LONG-TERM MANAGEMENT PLAN NORTHEAST CAPE FUDS

ST. LAWRENCE ISLAND, ALASKA

**Formerly Used Defense Site Nos.
F10AK0969-03 and F10AK0969-05**

**FINAL
SEPTEMBER 2016**

JACOBS	DATE:	06 JAN 2016	PROJECT MANAGER:	K. MAHER	FIGURE NO.:	A-3

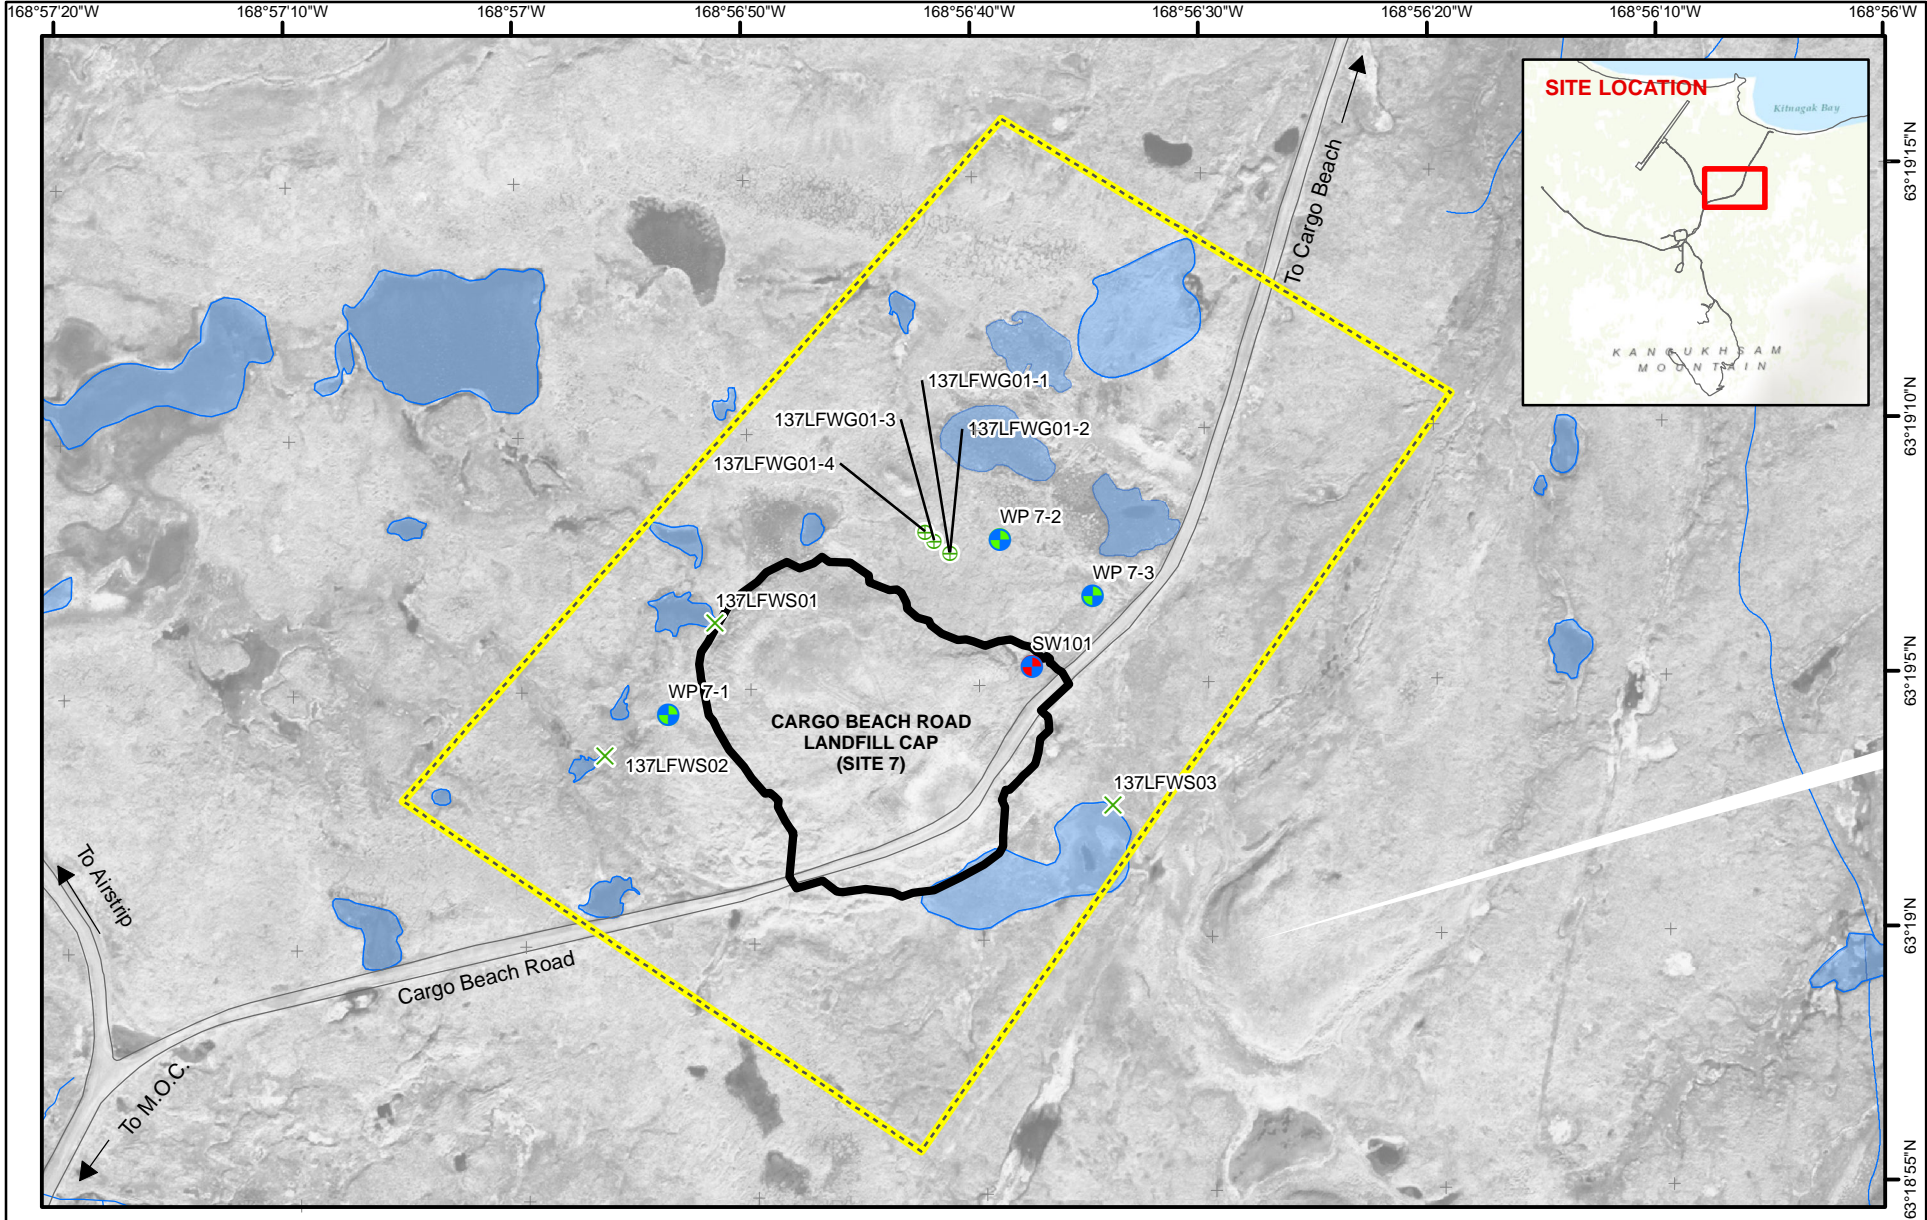
62.		Figure A-3	<p>The applicable narrative sections of the LTMP should discuss the rationale for selecting the depicted LUC areas i.e. Non-drinking Water Area; gradient, AOC of known residual contamination, etc. Discuss the size, placement of the area in relation to the site boundary, boundary of known contamination above applicable criteria, etc.</p>	<p>Accepted. The following text will be added as the last sentence of the first paragraph of Section 2.2: “The extent of the boundaries for the ‘Non-drinking Water Areas’ were established by placing each site, or sites,</p>

#	Page #	Section	ADEC Comment	Response
				at the center of a conservative buffer area.” ADEC-Accepted August 24, 2016
63.		Figure A-4	Why does the middle decision unit data box title include groundwater? Shouldn't this be surface water? If so then the applicable surface water results should be called out and detailed on the figure.	Accepted. Data boxes in Figure A-4 present sediment results. The title of the Middle Decision Unit data box will be revised to state: “Middle Decision Unit Composite Sediment Sample Results”. ADEC- Accepted August 24, 2016

NORTHEAST CAPE MOC MONITORING WELL LOCATIONS AND SELECT SAMPLE RESULTS NORTHEAST CAPE, SAINT LAWRENCE ISLAND, ALASKA			
JACOBS	DATE: 20 JUN 2016	PROJECT MANAGER: K. MAHER	FIGURE NO: A-7

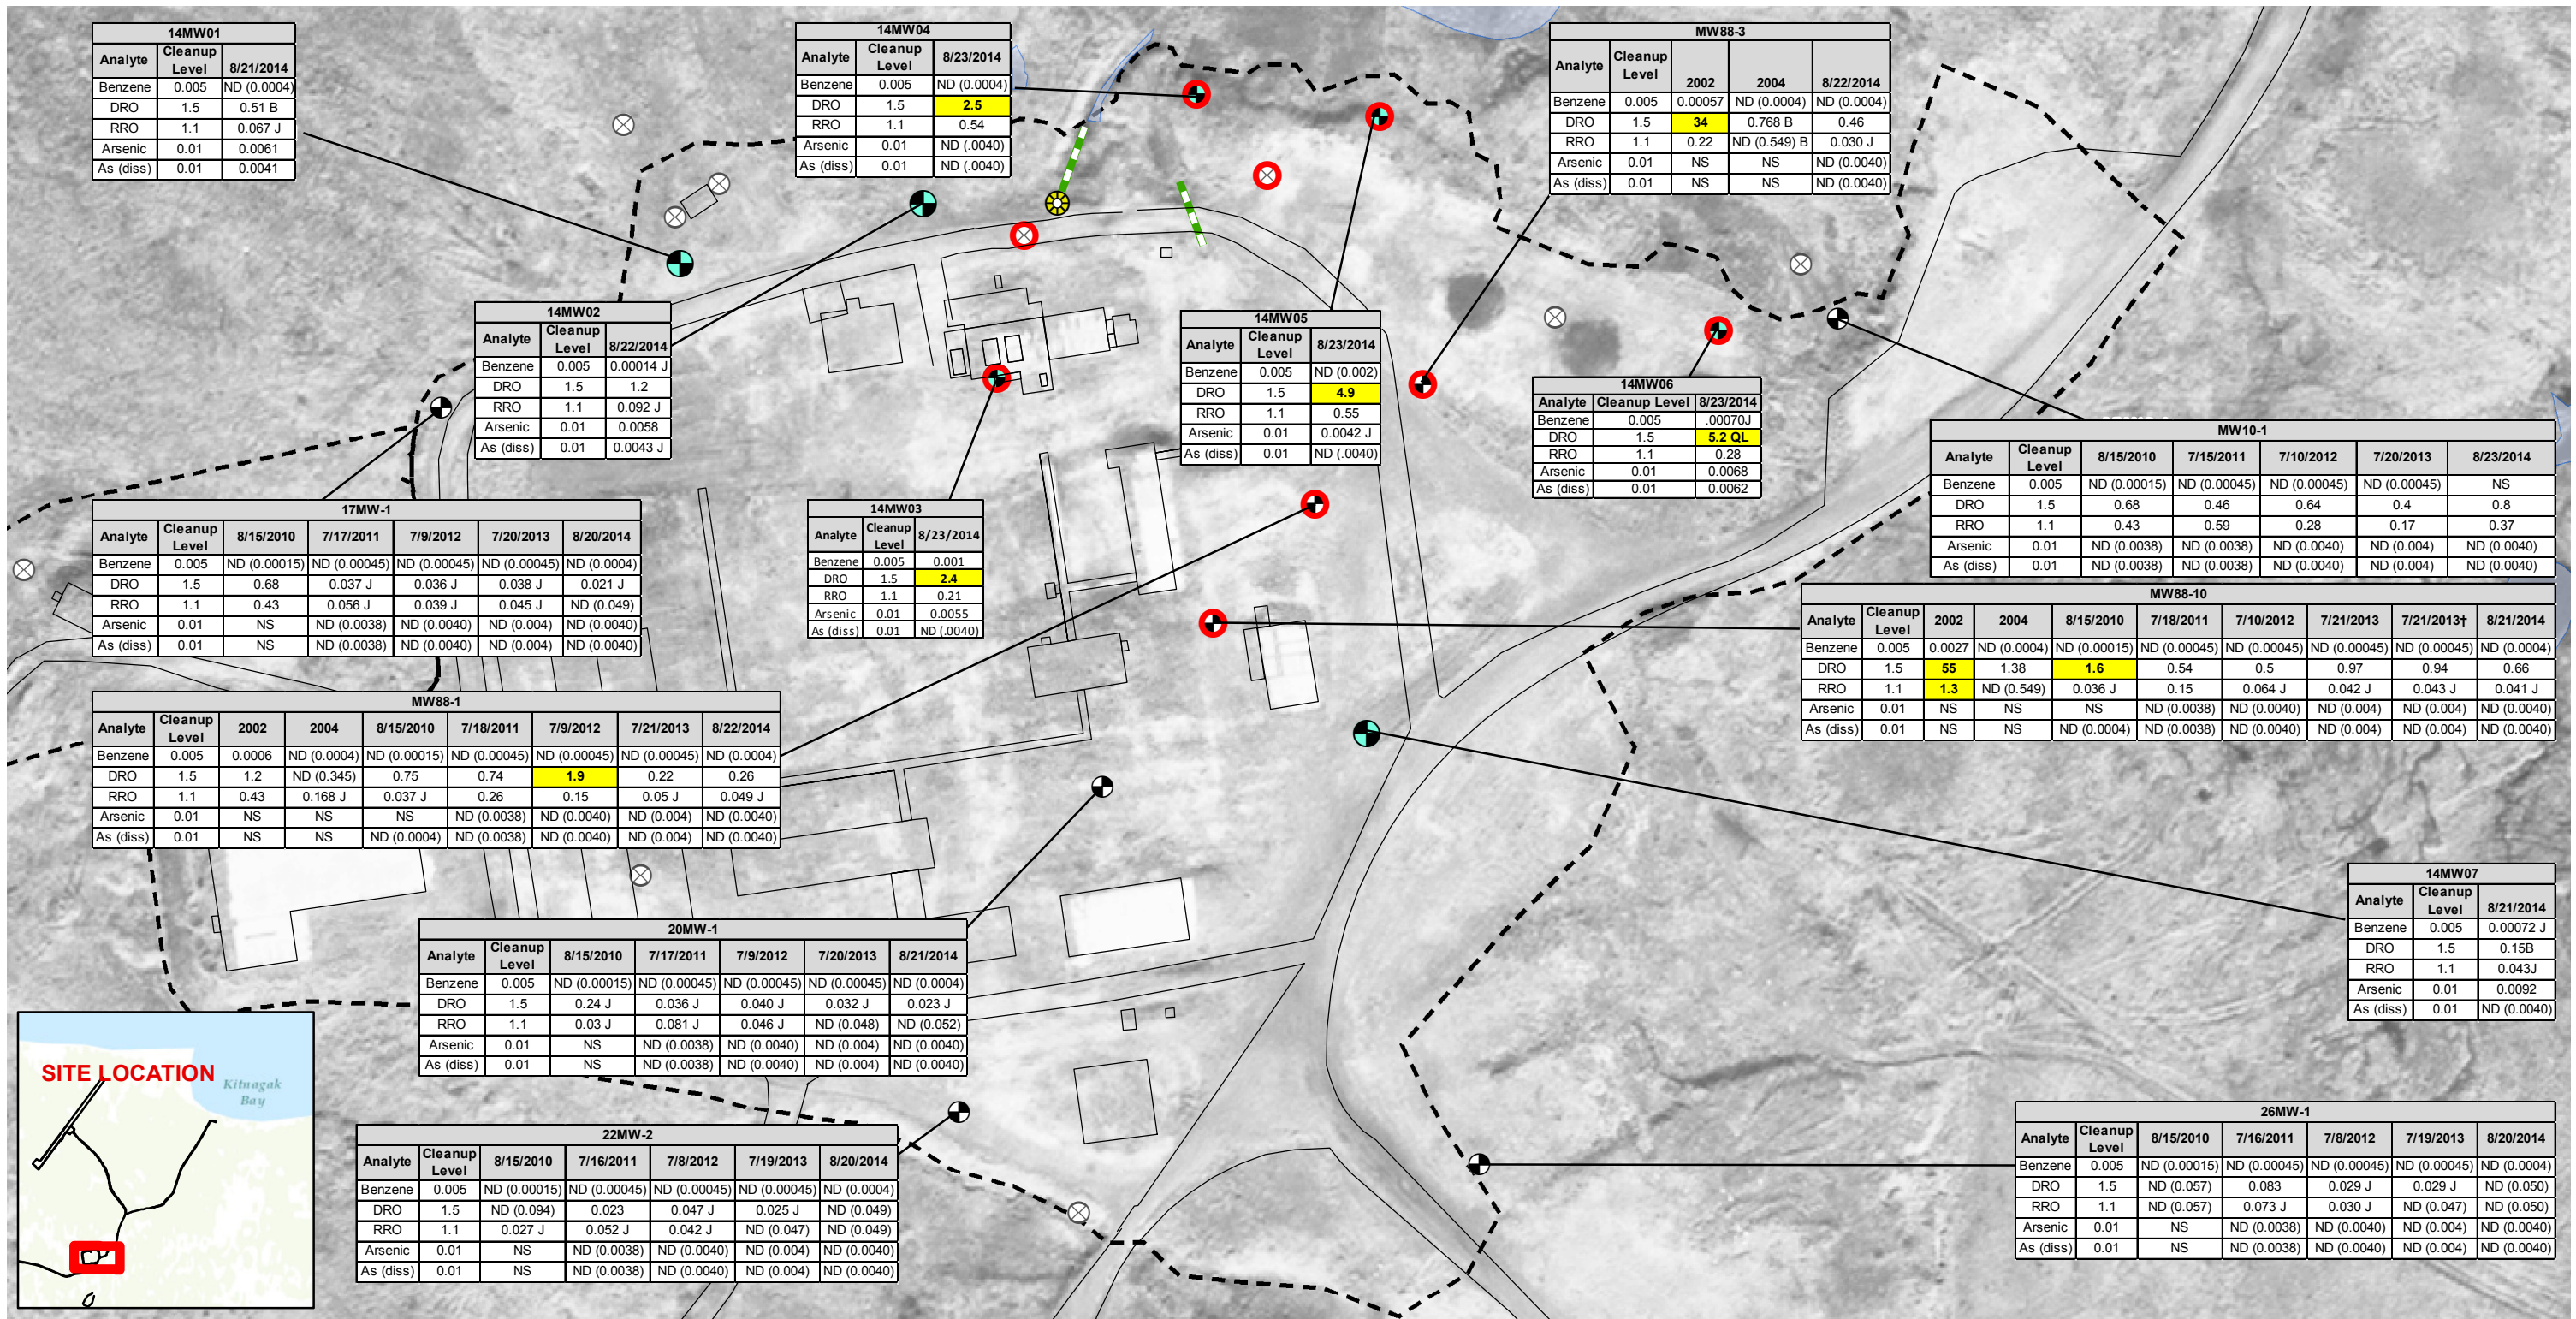
64.		Figure A-7	A figure note should be added that states that wells depicted as abandoned were either demolished during removal action activities or decommissioned due to site conditions.	Accepted. The following text will be added to the ‘Note’ Section of Figure A-7: “Abandoned wells were decommissioned due to site conditions or demolished during Remedial Actions”. ADEC- Accepted August 24, 2016

NORTHEAST CAPE SITE 28 - DRAINAGE AND EXCAVATIONS			
NORTHEAST CAPE, SAINT LAWRENCE ISLAND, ALASKA			
JACOBS	DATE: 15 JUN 2016	PROJECT MANAGER: K. MAHER	FIGURE NO: A-8

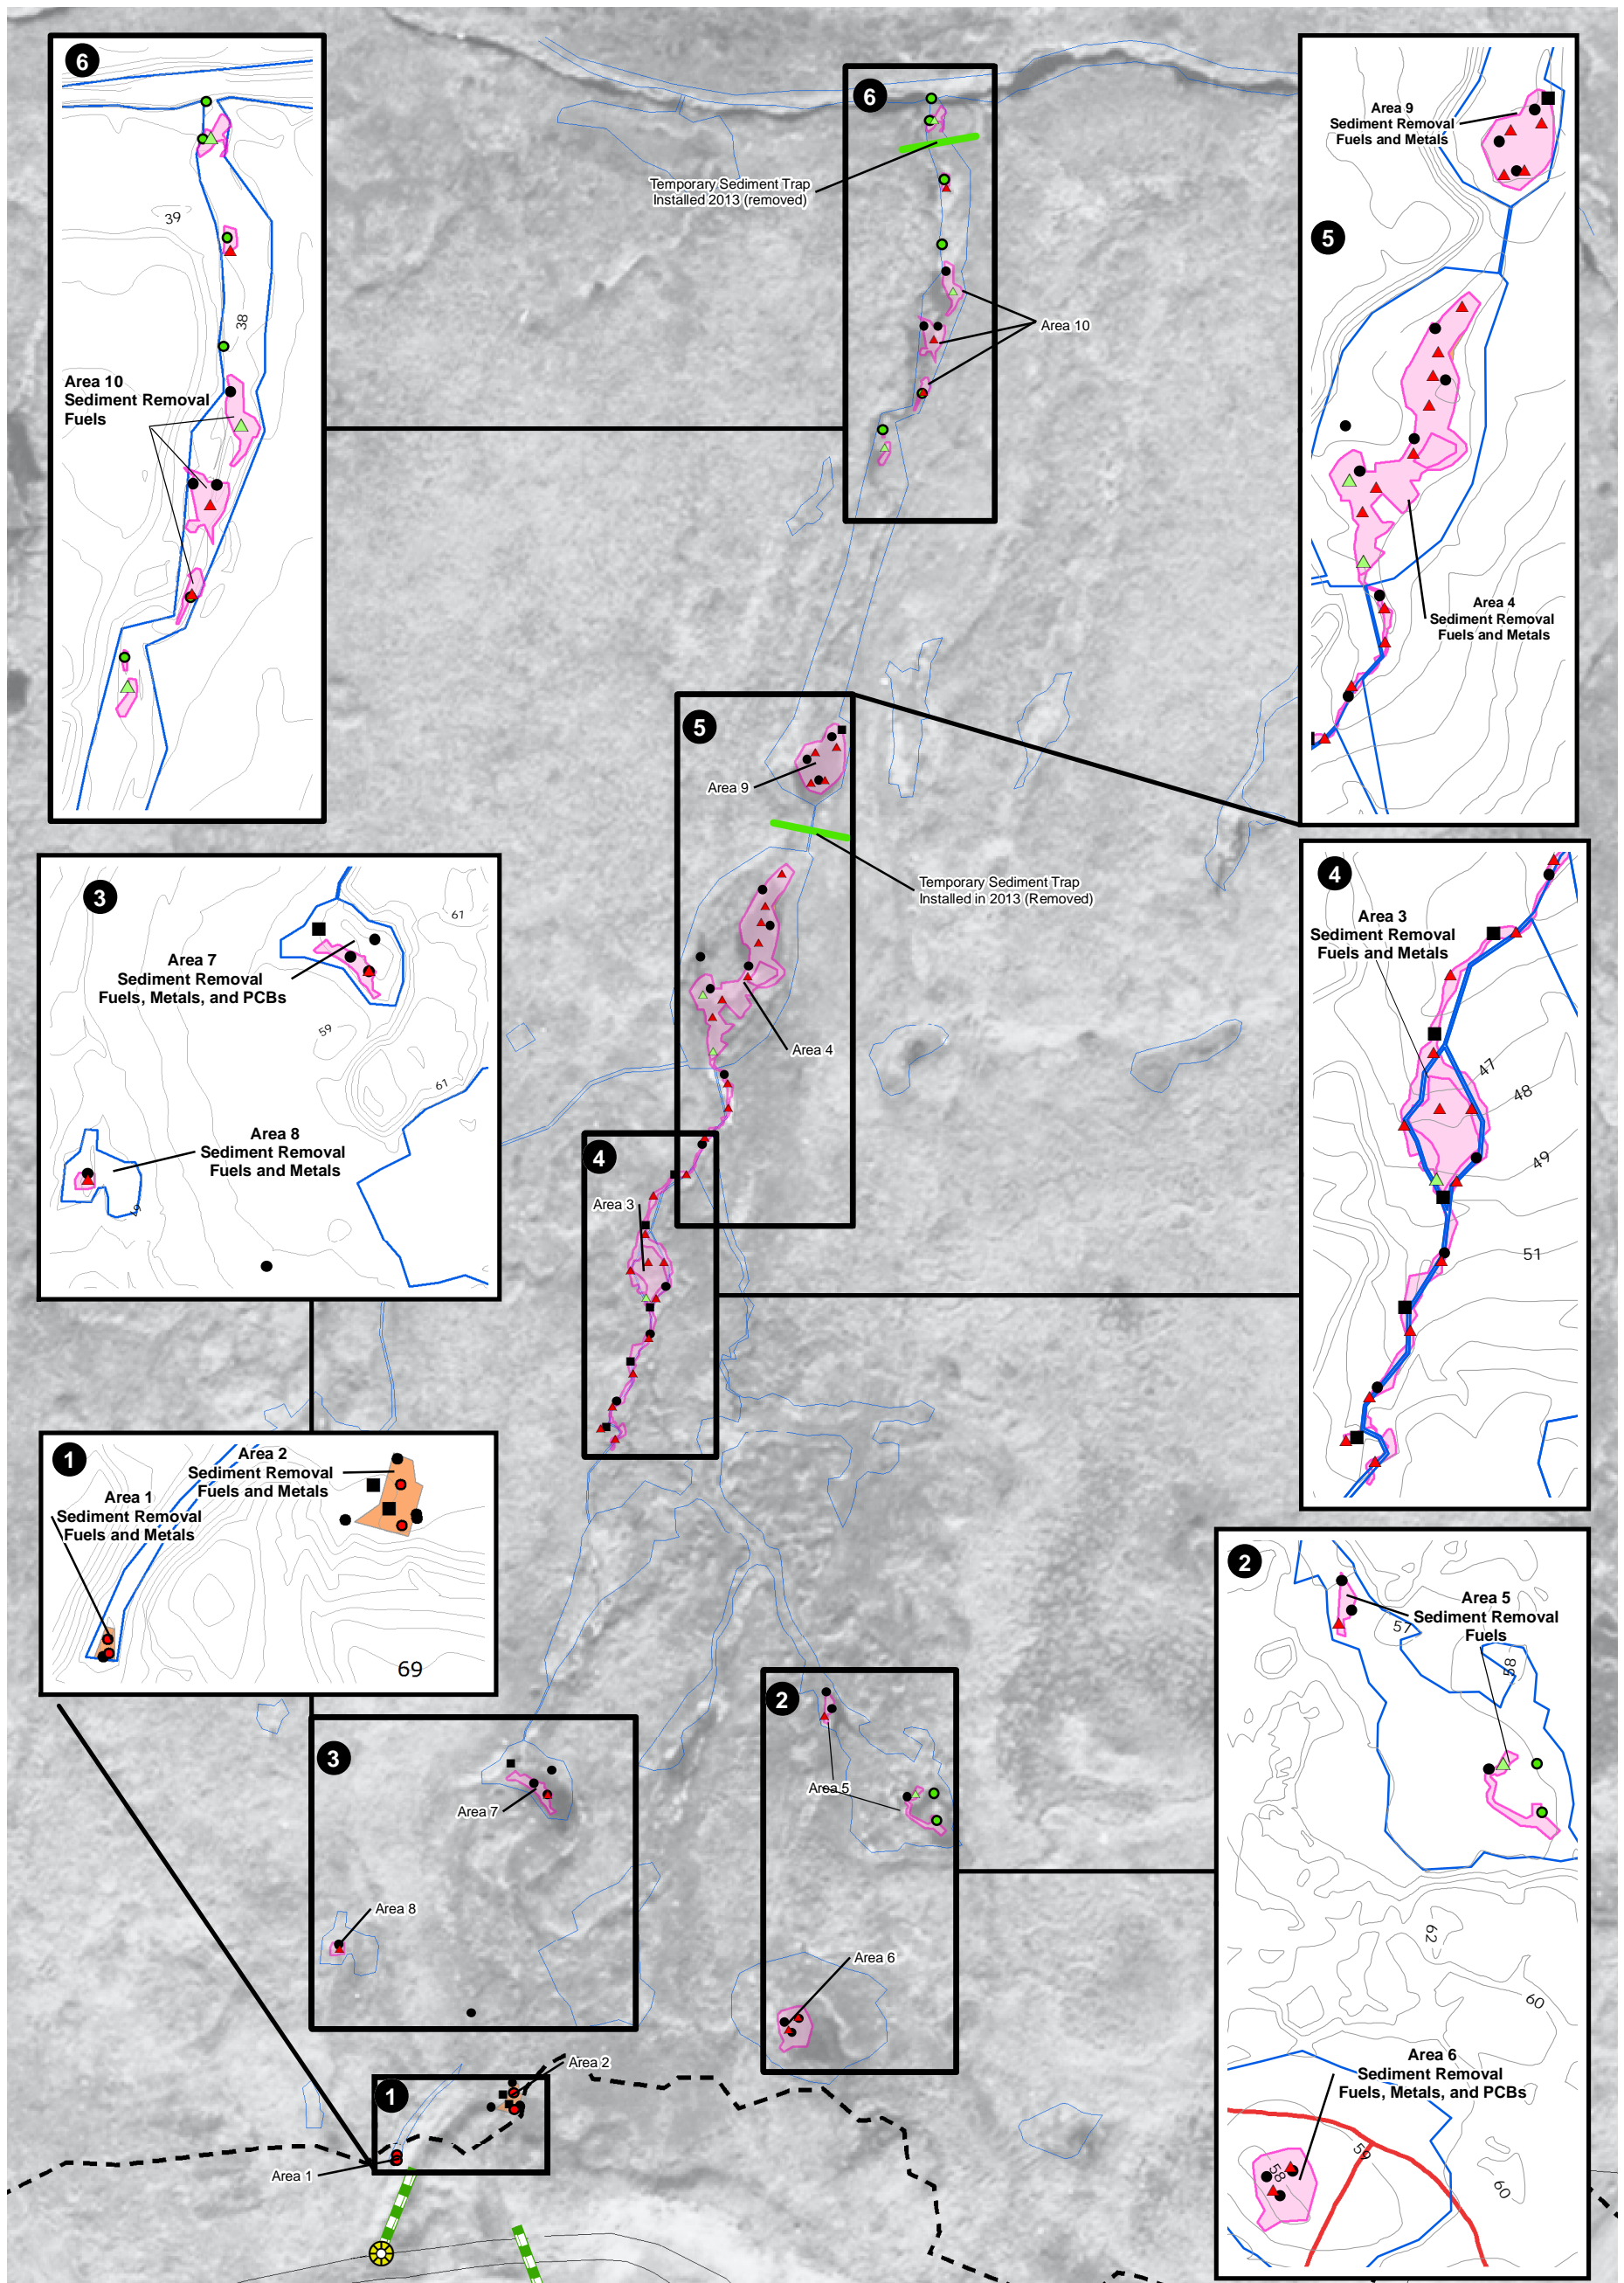
65.		Figure A-8	Please clarify the 2013 soil confirmation sample locations which are stated in the legend as having exceeded cleanup levels; whether or not contamination at these locations was removed.	Accepted. Figure will be revised to remove soil confirmation sample locations associated with Main Operations Complex excavations. Figure A-6 will be revised to show soil confirmation sample locations exceeding cleanup levels that remain in place. ADEC- Accepted August 24, 2016
